SUBJECT : ImageQuest Co., Ltd.
FCC ID: PJIL15A0C063
Class II Permissive Change
Orig. Grant Date: March 11, 2003

Transmitted herewith, on behalf of ImageQuest Co., Ltd. is an application for a Class II Permissive Change Certification of the following 15-inch LCD Monitor:

FCC ID : PJIL15A0C063
Model/Type : L50S/L15A0C063

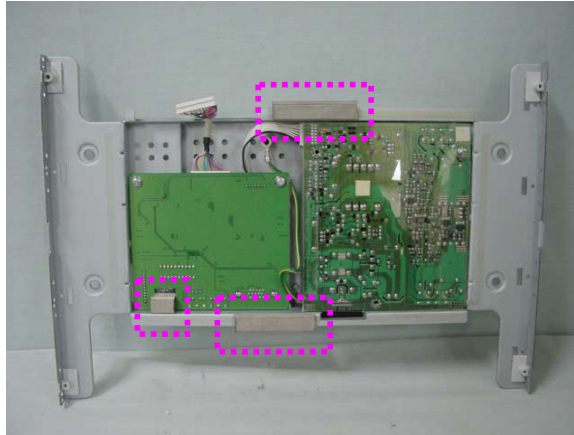
1. Attach a gasket on the main frame and main board to contact the lcd panel

2. Apply ferrite core to OSD signal line
